**TO:** River Valley Church  
**FROM:** Jesse Corrow, City Planner  
**DATE:** May 18, 2023  
**SUBJECT:** River Valley Church Review Comments

**TO: Jesse Corrow**  
**FROM: Brandon Stenglein**  
**DATE: 6/12/23**  
**PROJECT NAME: River Valley Church**  
**LOCATION: 101st Ave & Arbor Ridge Parkway**  
**PID:**  
**SUBMITTAL: Condition Use Permit**

RE: River Valley Church - Site Plan Review

**SUBJECT:** River Valley Church Addition

### SIGHT TRIANGLE EXAMPLE

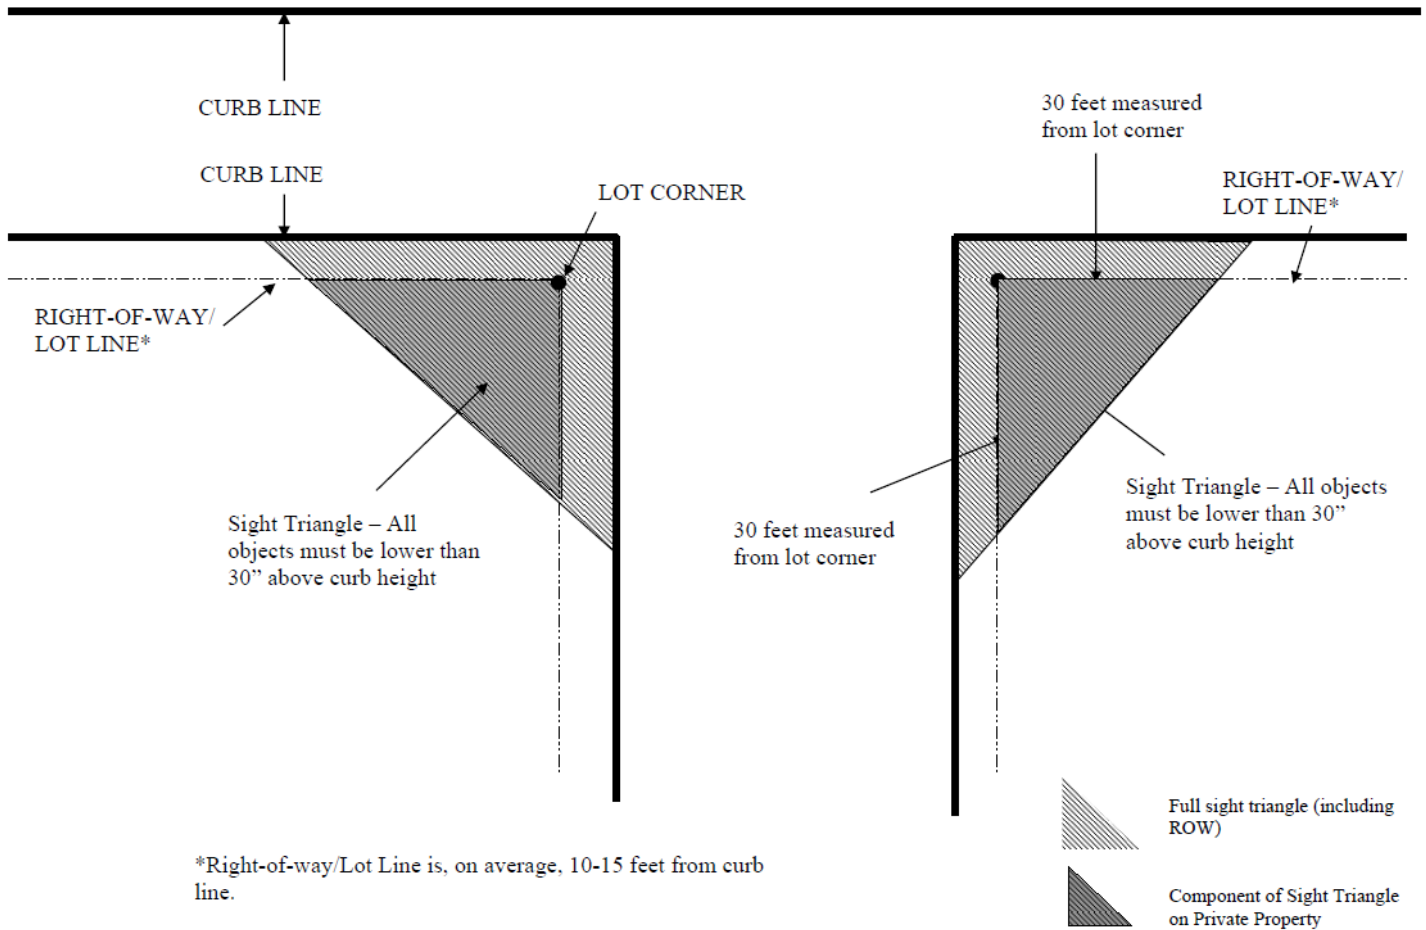
It appears that there might be some trees / landscaping located within the sight triangle at the proposed church access along Arbor Ridge Parkway. The applicant should review the placement of the proposed landscaping near access driveways, and modify as needed to eliminate potential sight obstructions within the sight triangle

a. (refer to the attached Ordinance regarding sight triangles).

On corner lots in all districts, no structure or planting in excess of 30 inches above the street centerline grade shall be permitted within a triangular area defined as follows: beginning at the intersection of the projected property lines of two intersecting streets, thence 30 feet along one property line thence diagonally to a point 30 feet from the point of beginning on the other property line, thence to the point of beginning.
